SUBDIVISION COMMITTEE
METROPOLITAN AREA PLANNING COMMISSION

STAFF REPORT
(Final Plat)

CASE NUMBER: S/D 94-39 HOSKINSON ADDITION

VICINITY MAP:

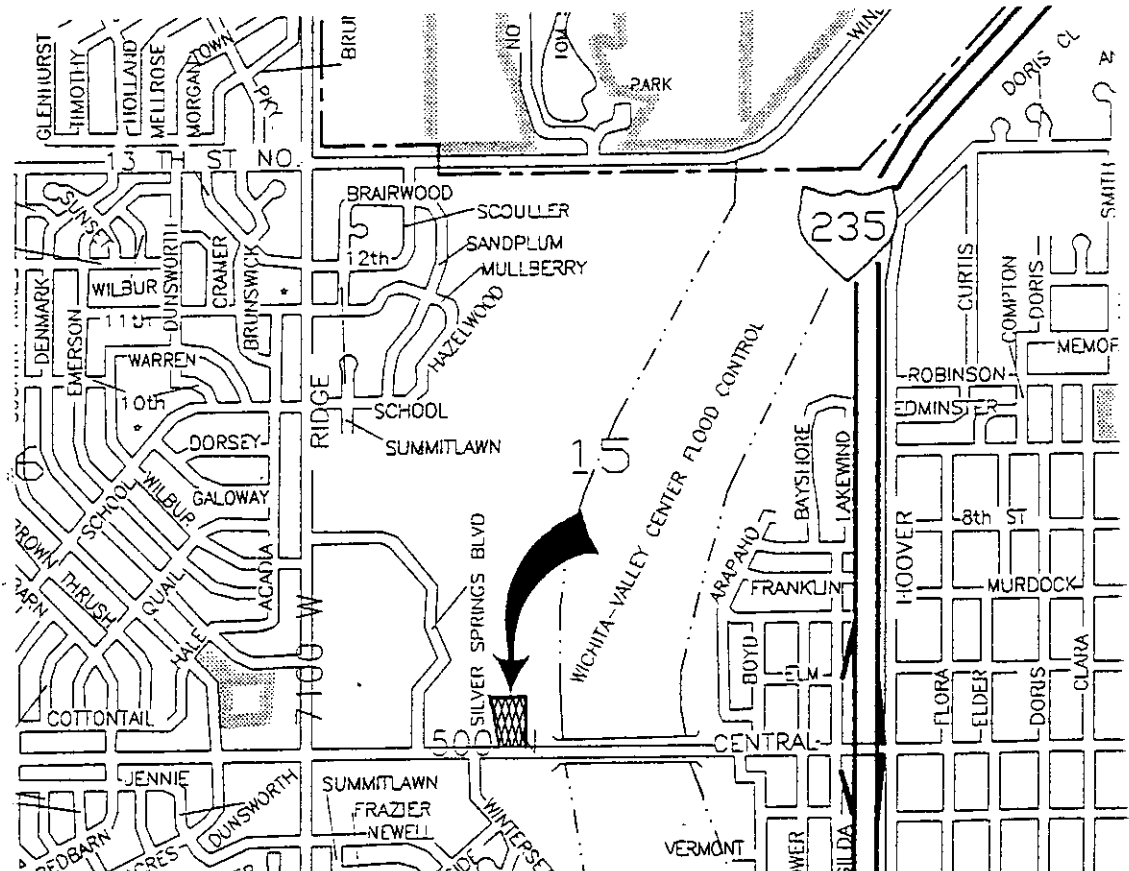
NOTE: This site is immediately adjacent to the Wichita Floodway (Big Ditch). Much of the site is also encumbered by various easements, especially for drainage. Only a strip of the property along the east line of the site appears to be unencumbered by easements or dedications and consequently is the only developable portion of the site. The supposed proposed use for the site is a Restaurant.
